Addendum #2 – Issued December 3, 2012

Regarding Bids for **Engineer Road Maintenance Building – MEP, Fire Protection, General Trades & Fueling System (ITB 12-032P)** for Lucas County Engineer Road Maintenance, bid opening scheduled for December 6, 2012 at 2:00 P.M. (local time).

ADDENDUM NO. 02

Lucas County Road Maintenance Building
Bid Package #12-032P – Plumbing, Mechanical, Electrical, Fire Protection,
General Trades and Fueling Station Packages
Dated 12/3/2012

A1 FIRST FLOOR PLAN
SCALE: 1/4" = 1'-0"

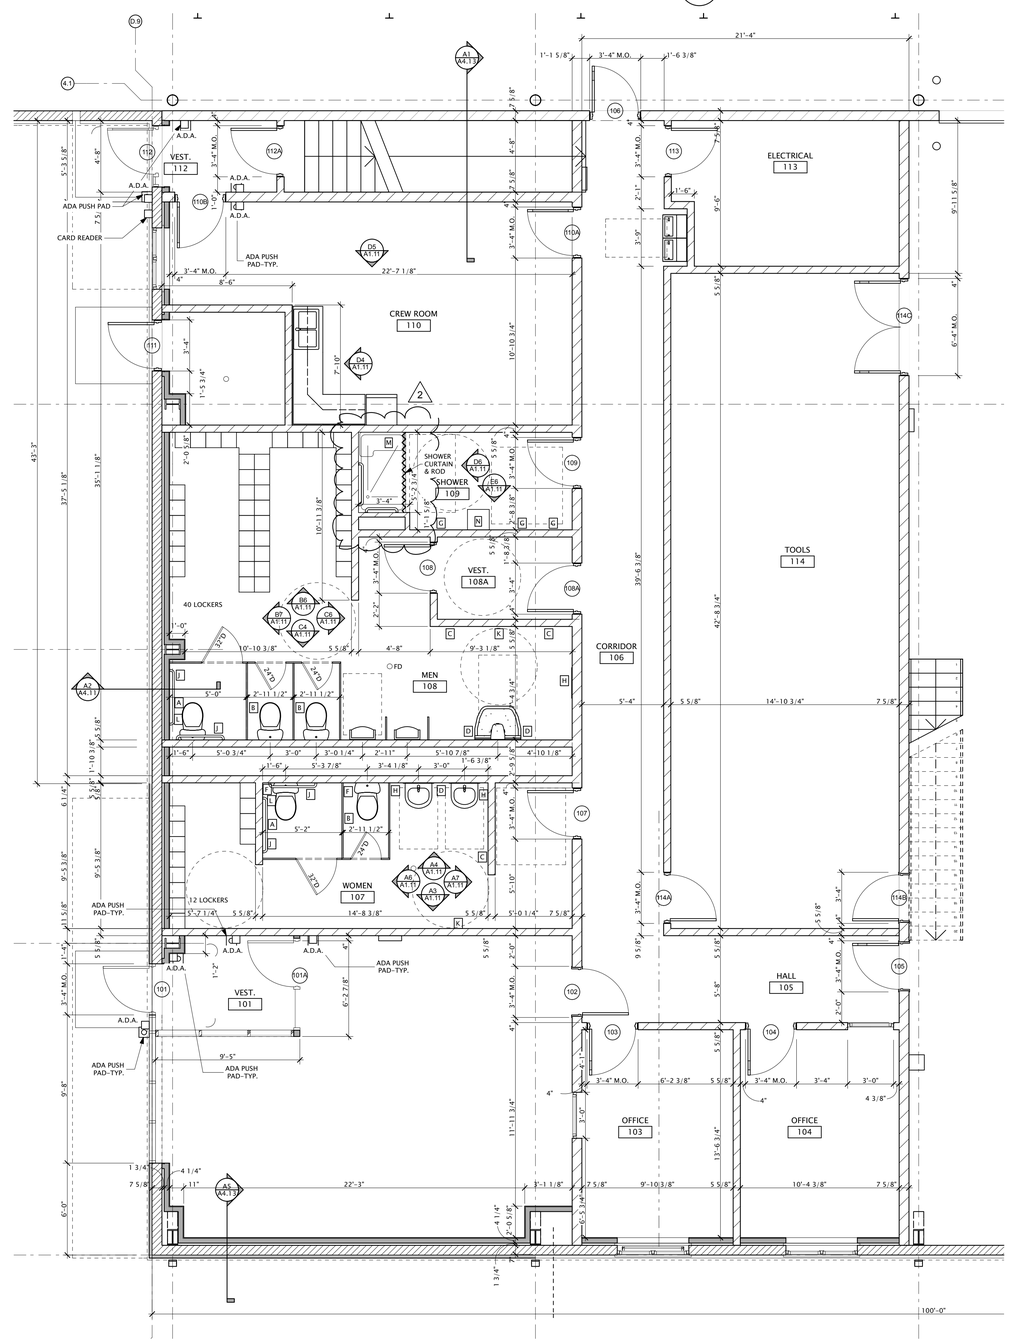
Drawing A1.11 "Enlarged Plans & Interior Elevations" – (Re-issued)
Item #1 Revised shower unit and room configuration for Shower 109.
Item #2 Revised elevation D6 on sheet A1.11 to reflect revised configuration.

SHEET NO.
A3.01

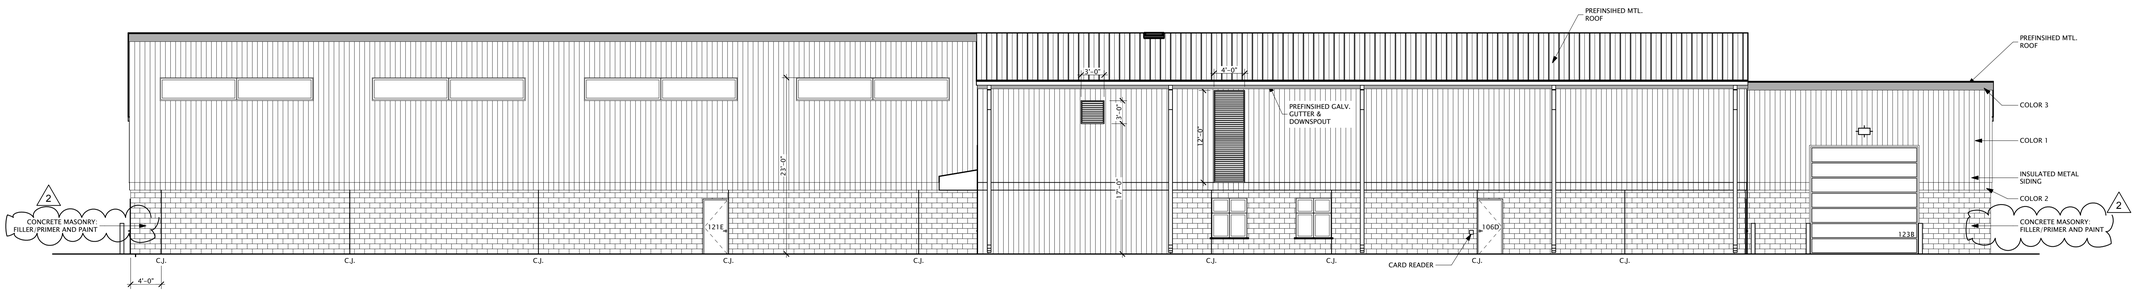
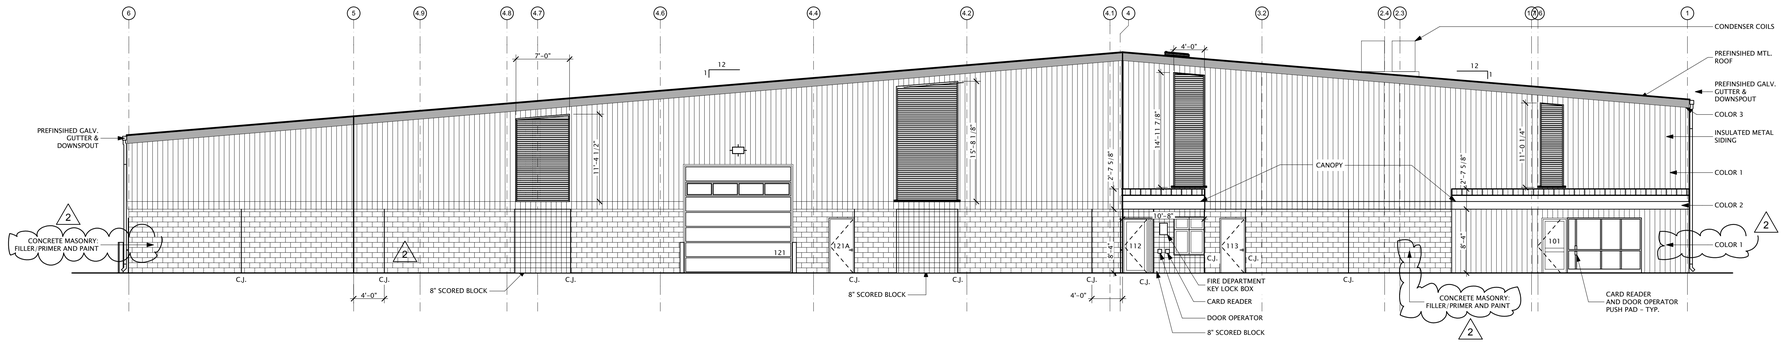
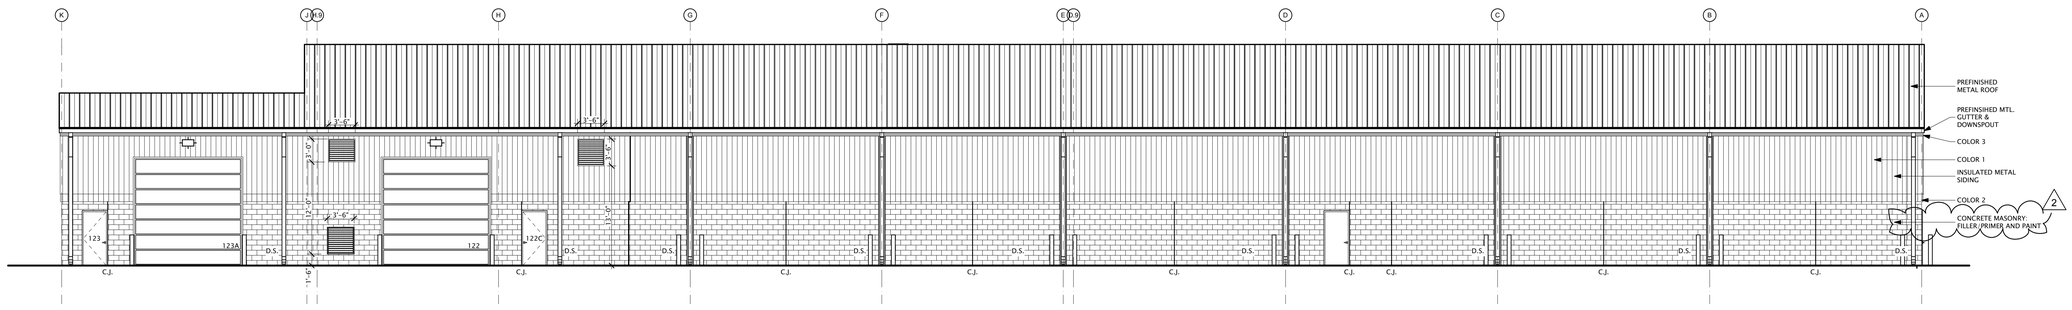
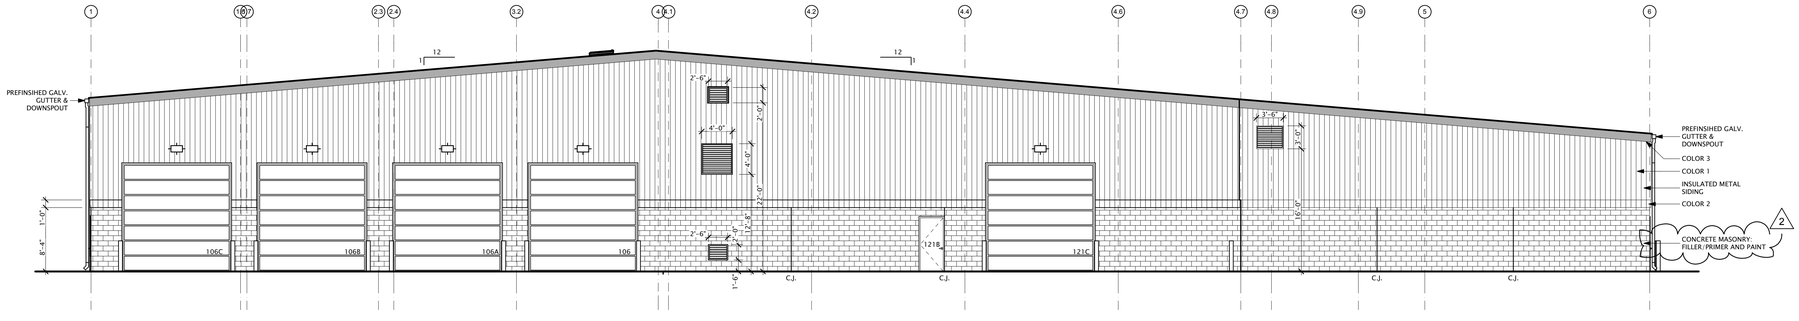
Drawing A3.01 "Exterior Elevations" – (Re-issued)
Item #1 Added clarification note on exterior paint for exterior concrete masonry units.

A1 / A7.31 **1st FLOOR DISTRIBUTION PLAN**

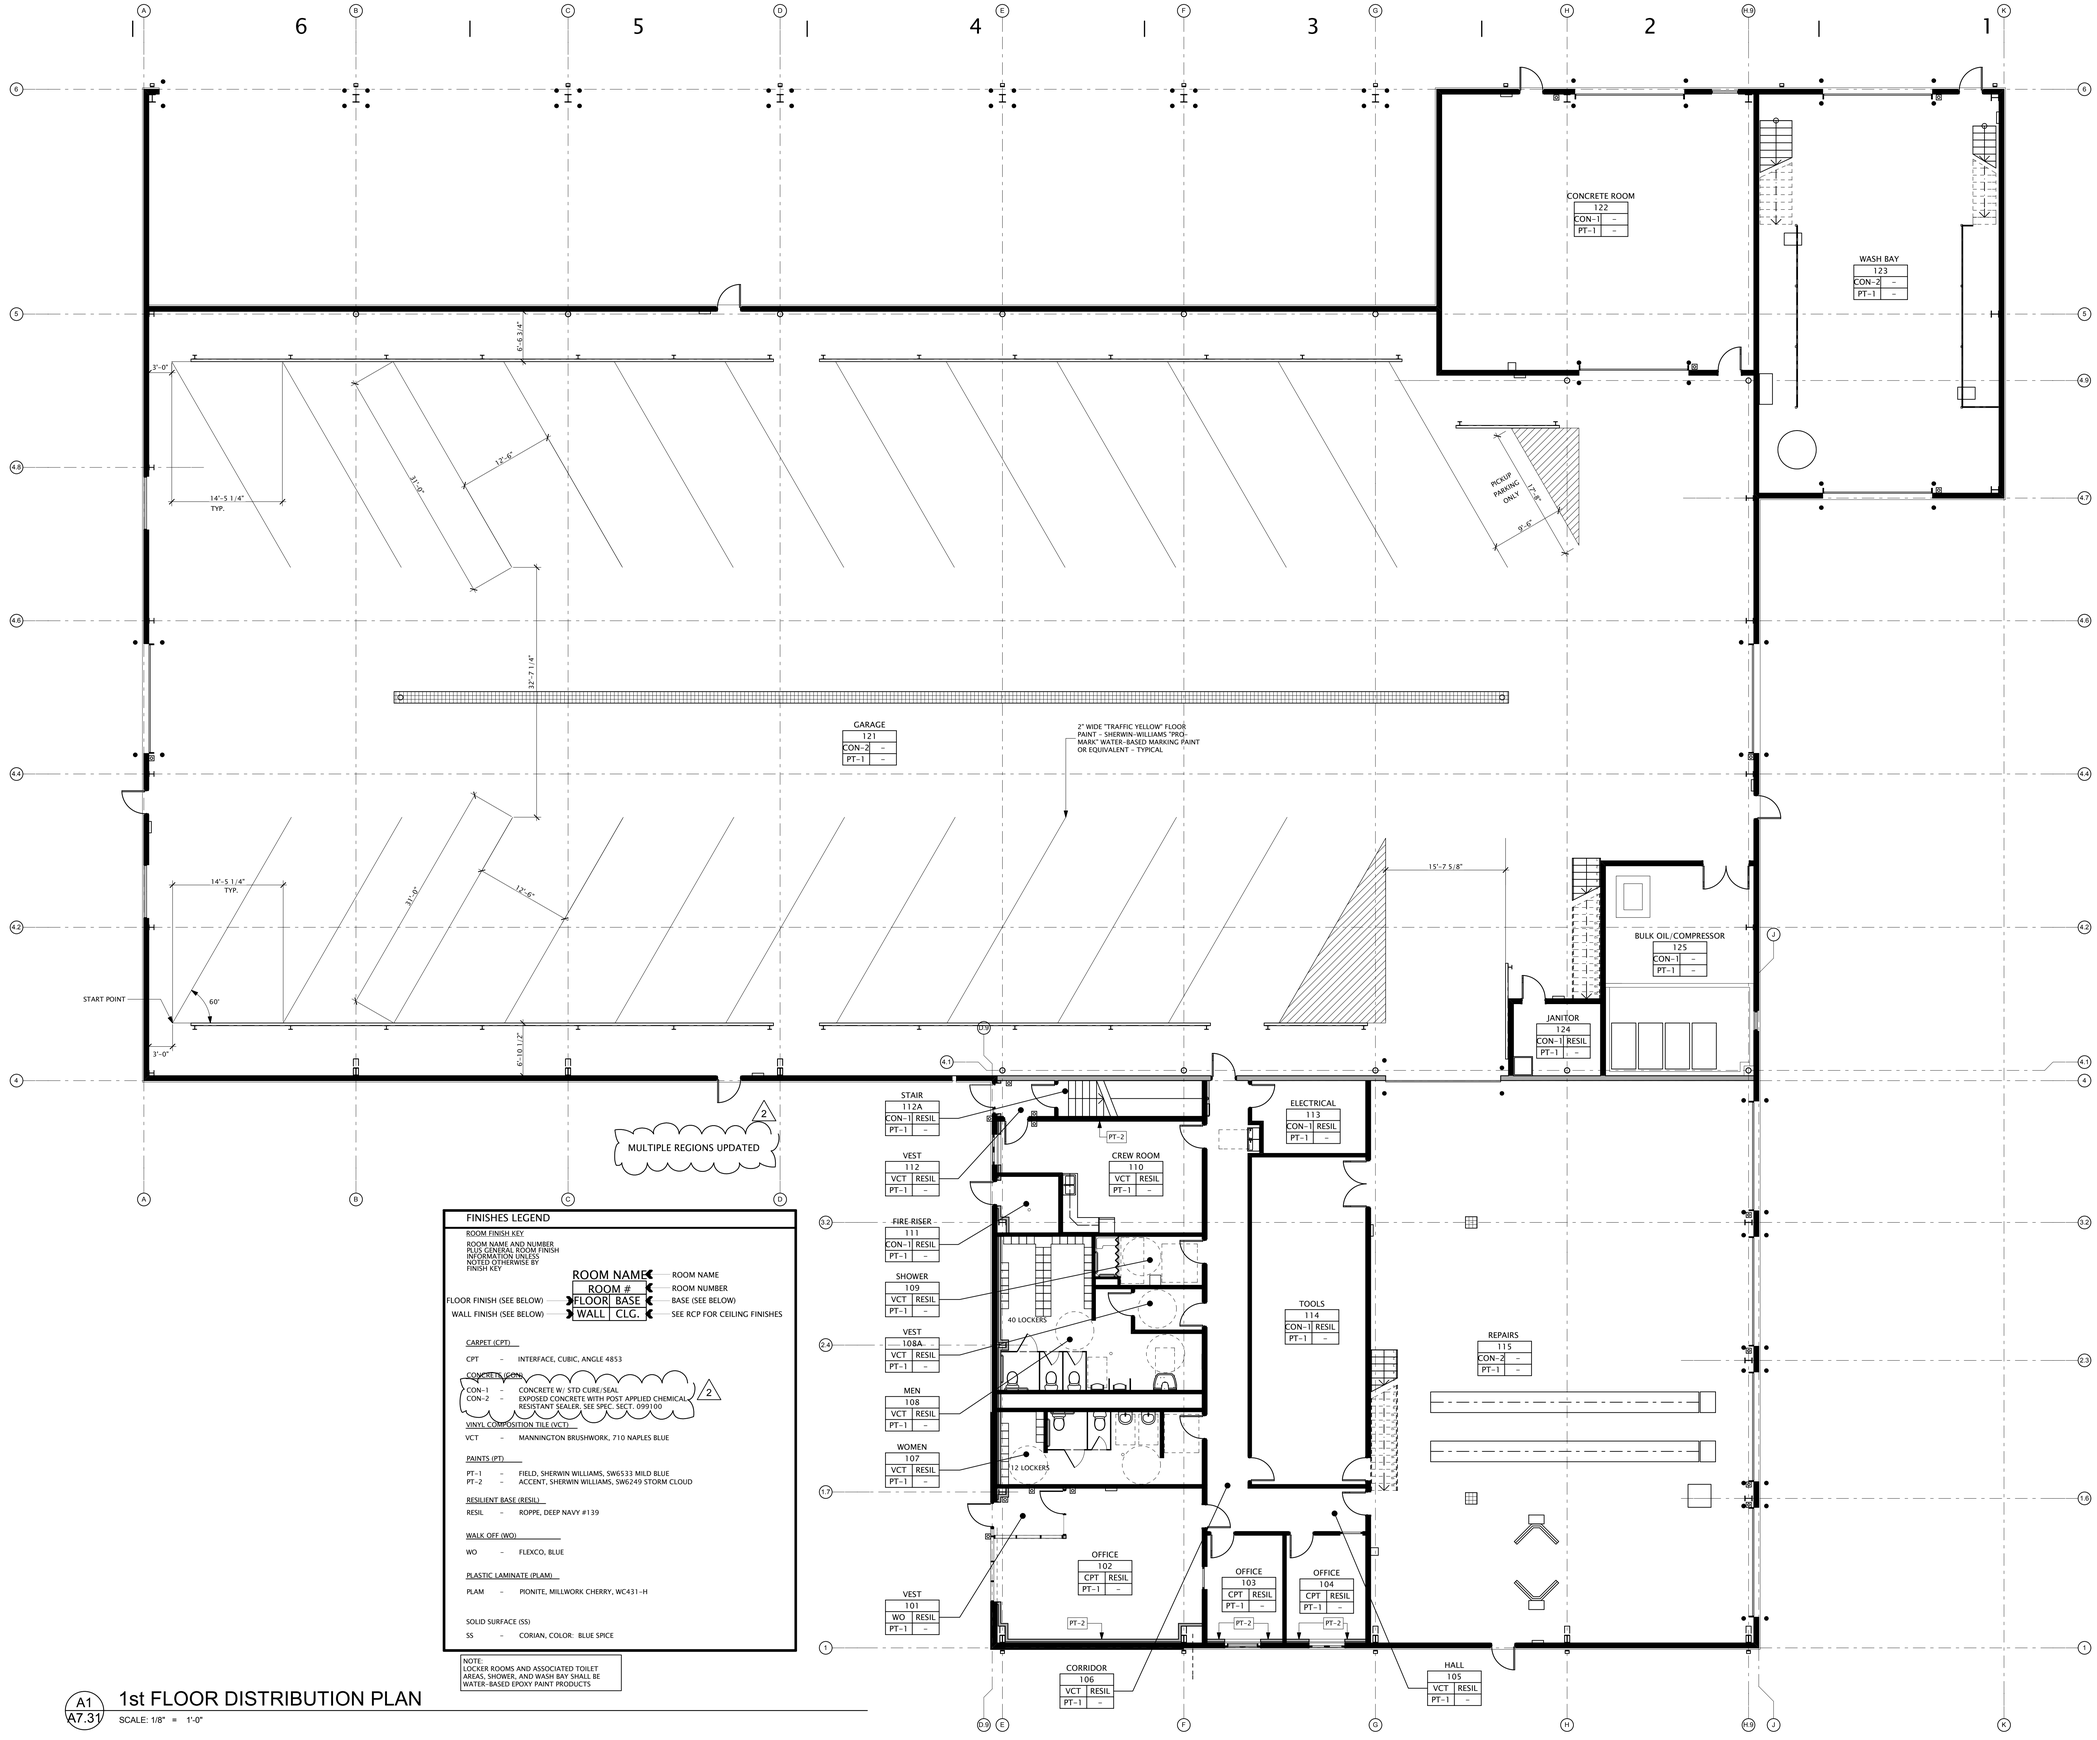
Drawing A7.31 "First Floor Finish and Parking Layout Plan" – (Re-issued)
Item #1 Corrected room finishes; added paint, floor and base material designations.

A7.32

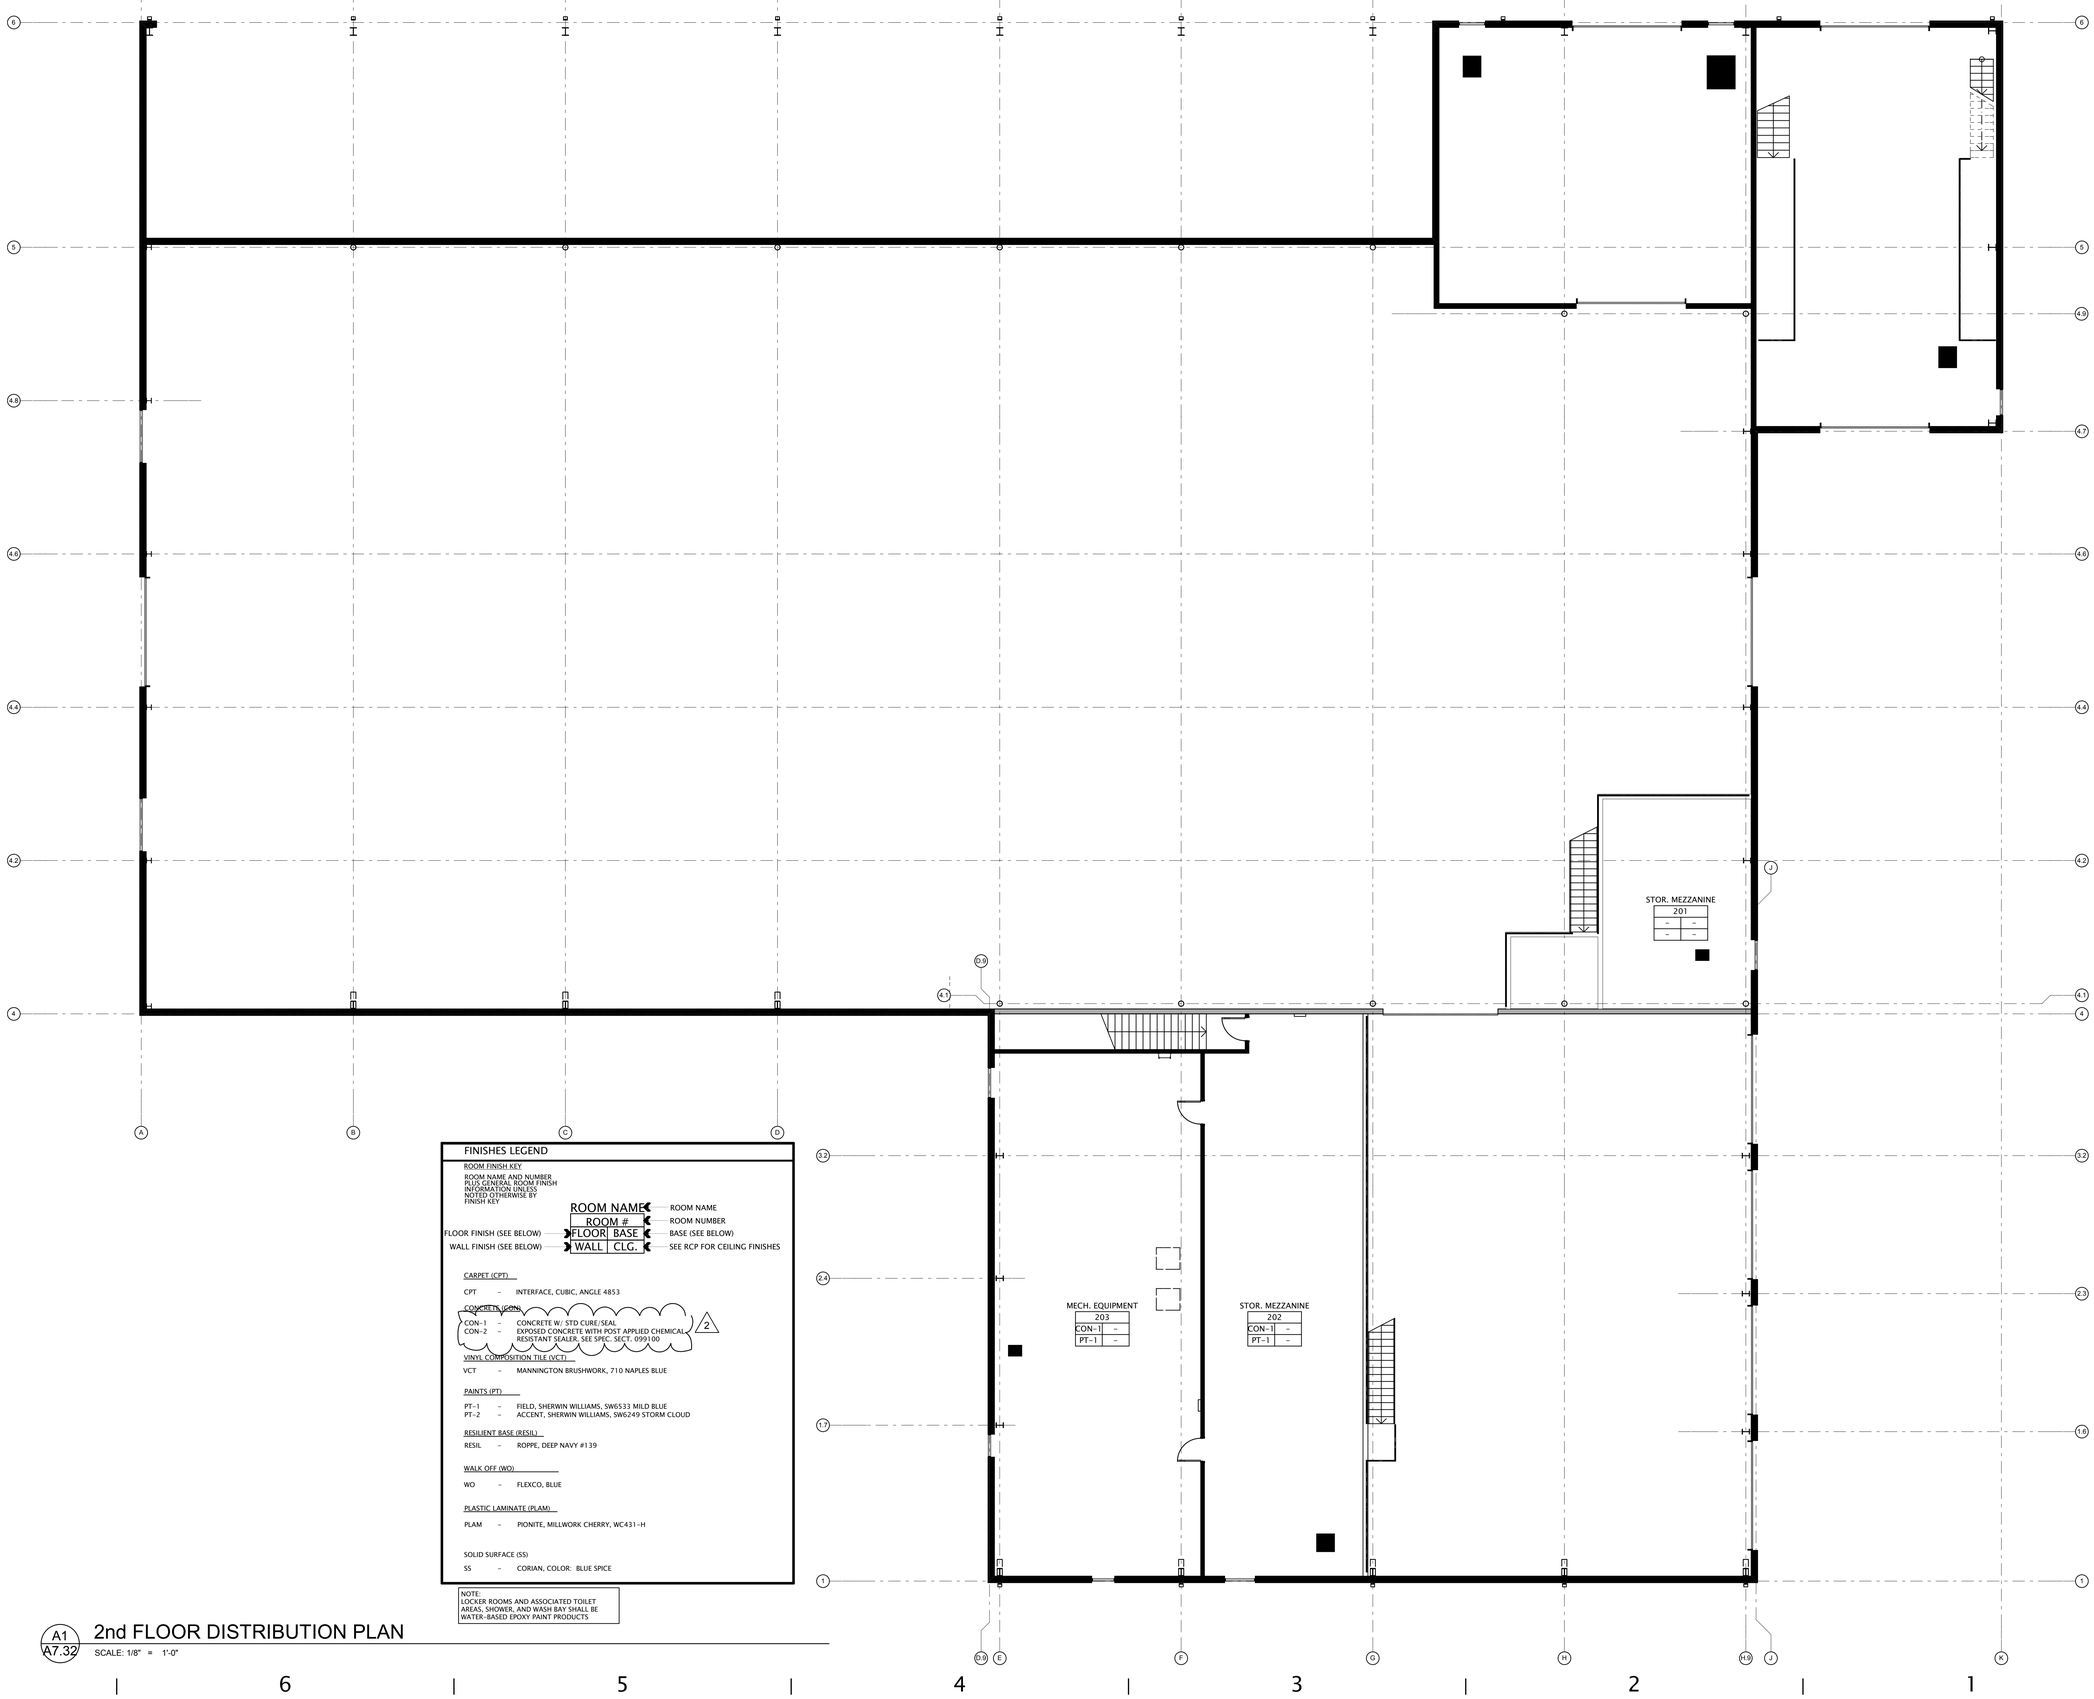
Drawing A7.32 "Second Floor Finish Plan" – (Re-issued)
Item #1 Corrected room finishes; added paint, floor and base material designations.
